LOG NO.
9029

FINGER PLATE CUTTING DETAIL

OUT FOR APPROVAL	2/6/97									
OUT FOR APPROVAL	2/9/97									
ISSUED TO SHOP										
FIELD & OFFICE										
REV.	REMARKS	DATE	DWN	CHK	APP	Q.A.	NO.	DIA.	LG	
	PROJECT NO. BR5-RS 0/13 (S)									
MATERIAL:	ELECTRODES	GENERAL NOTES: SEE								
HOLES:	SHOP BOLTS									
SURFACE PREP. & PAINT:	SEE NOTES DRG. NO. 2									
DESCRIPTION:	FINGER JOINT DETAILS	DRG.								
JOB:	STATE OF VERMONT A.O.T. BRIDGE No. 44 U.S. ROUTE 5 OVER BLACK RIVER TOWN OF SPRINGFIELD	CH								
CUSTOMER:	WINTERSET, INC.	APP								
BRIDGE & STEEL SERVICES		4								
5 INDUSTRY ROAD SOUTH PORTLAND, ME 04106		3								
PHONE (207) 874-2017 FAX (207) 874-8998

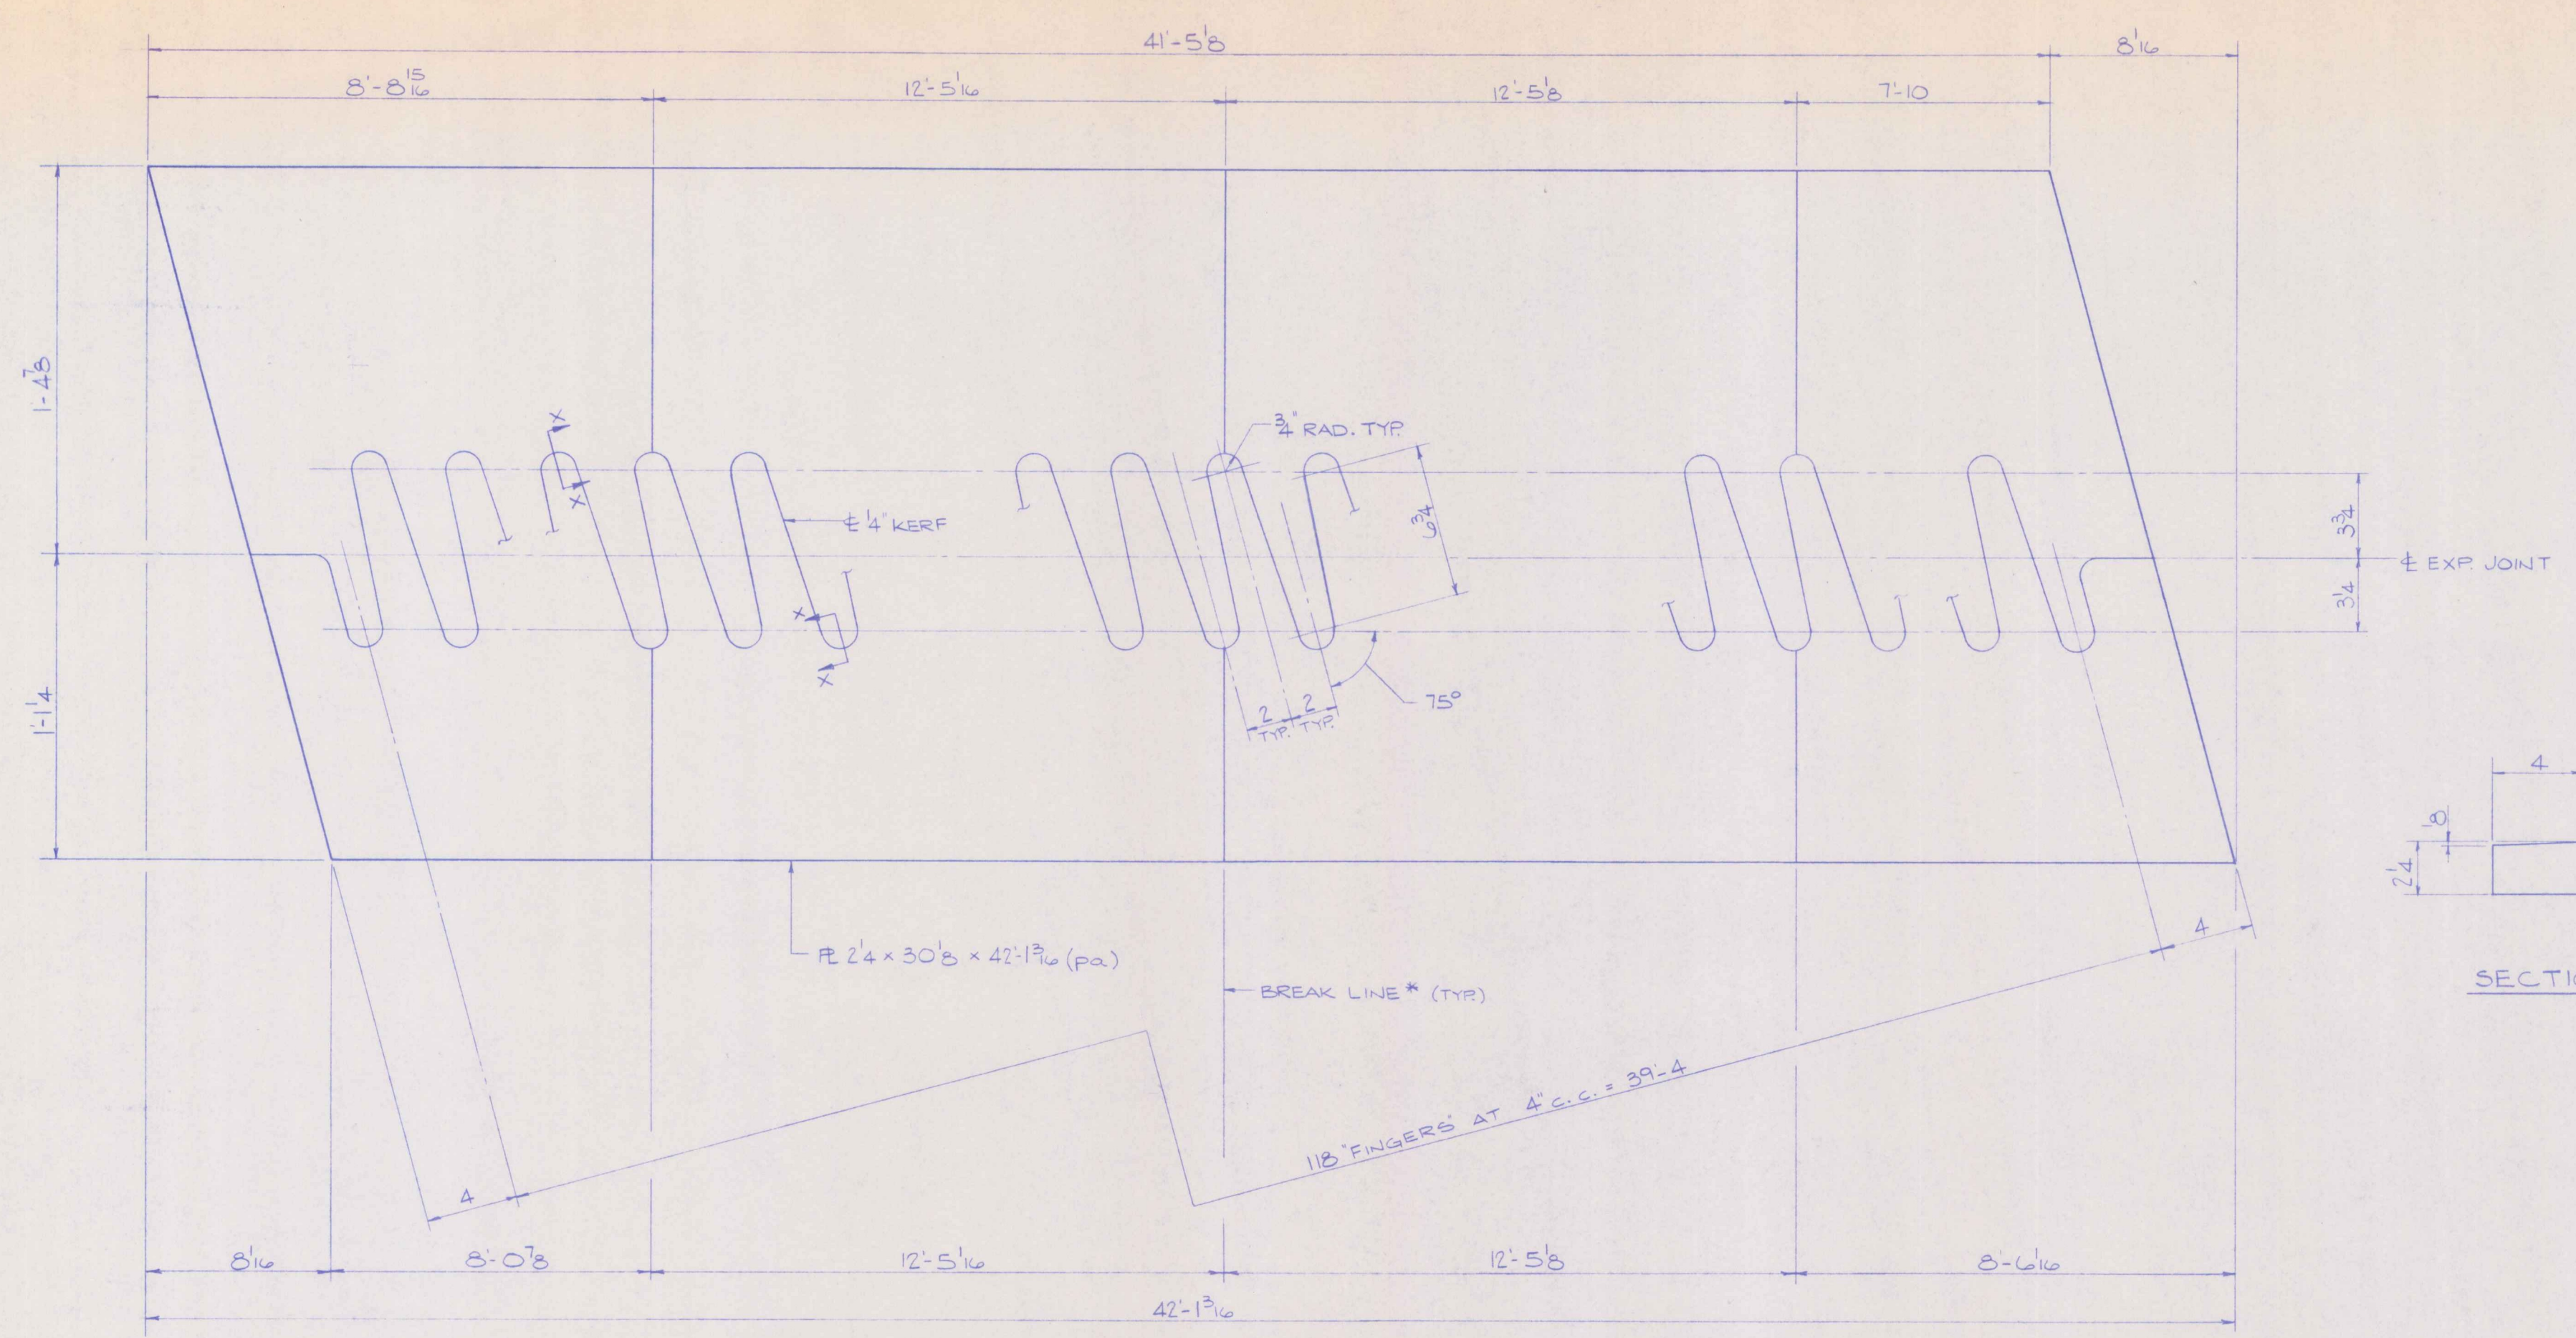
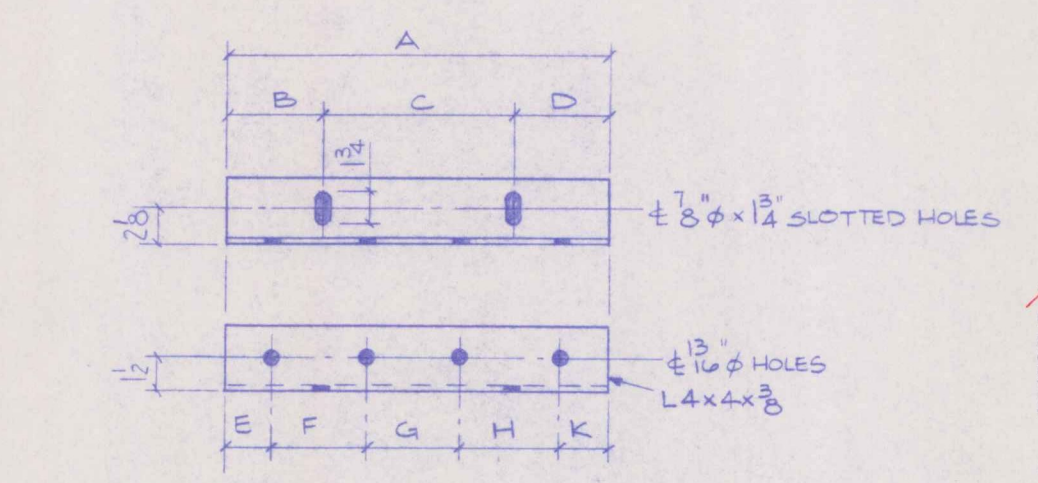
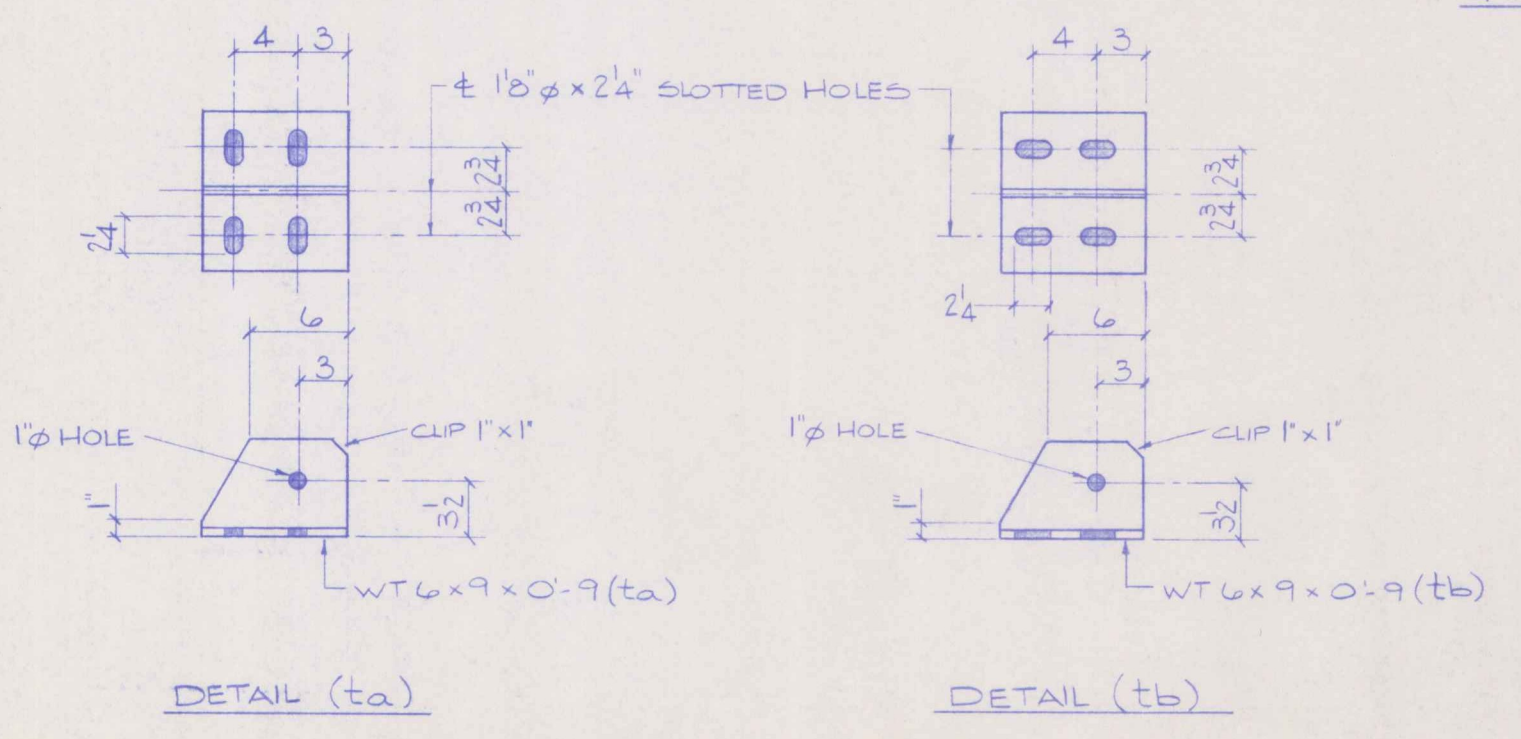
No Exception Taken Make Corrections Now!
 Fixing and Reinstall Not Acceptable
 Reviewed only for general conformance with the design and specifications. The contractor is responsible for confirming and controlling all dimensions and dimensions and performing the work in a satisfactory manner.
 DATE: 2/1/97 BY: s.p.
